## Declaration letter

**Model No.:** Deco XE75, Deco XE5300, Deco XE75 Pro

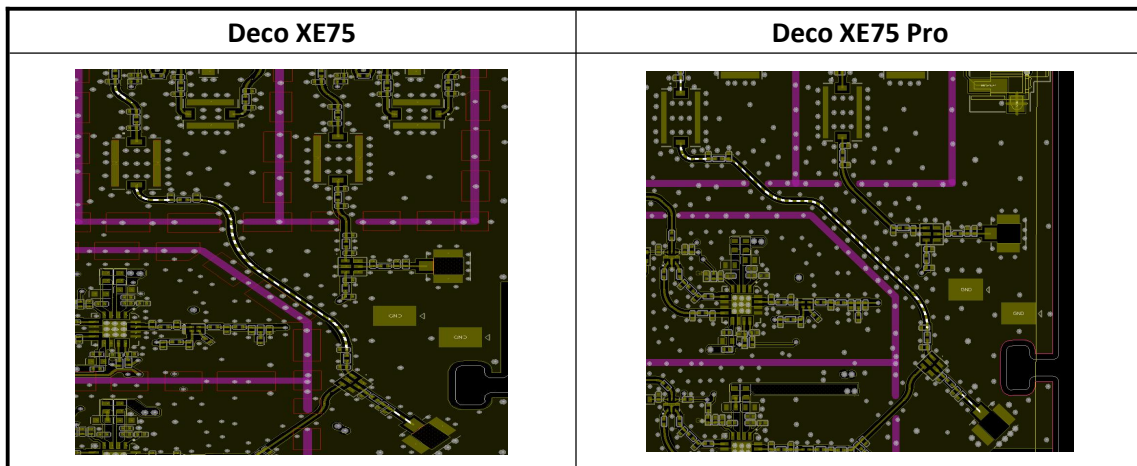
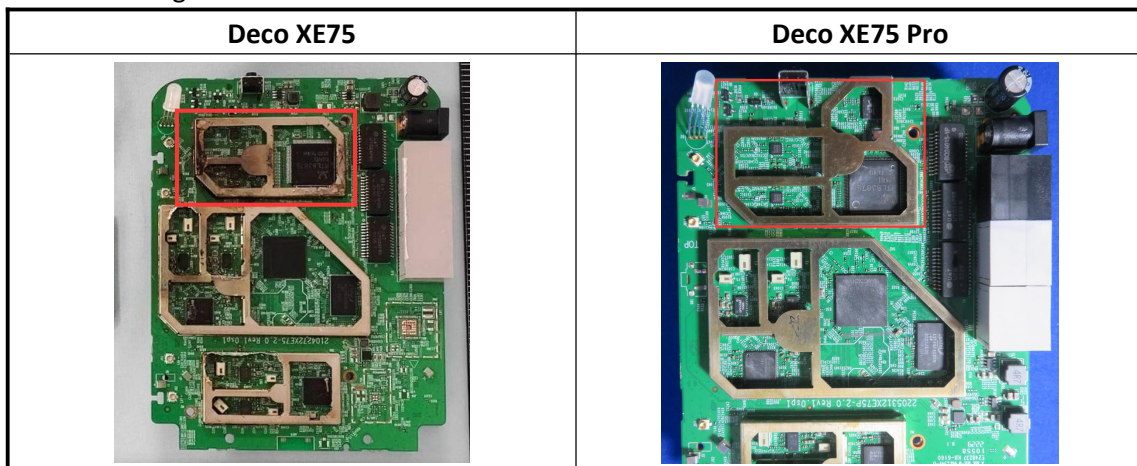
Hardware design and PCB layout are the same between Deco XE75 and Deco XE5300, only the model for our marketing strategy is different.

The difference between Deco XE75 Pro and Deco XE75 & Deco XE5300 as follows:

1. Ethernet chip is changed.
2. The color and size of RJ45 connector is different.
3. Wi-Fi 5G RF trace is moved.

4. Shielding case of Wi-Fi 2G is different.
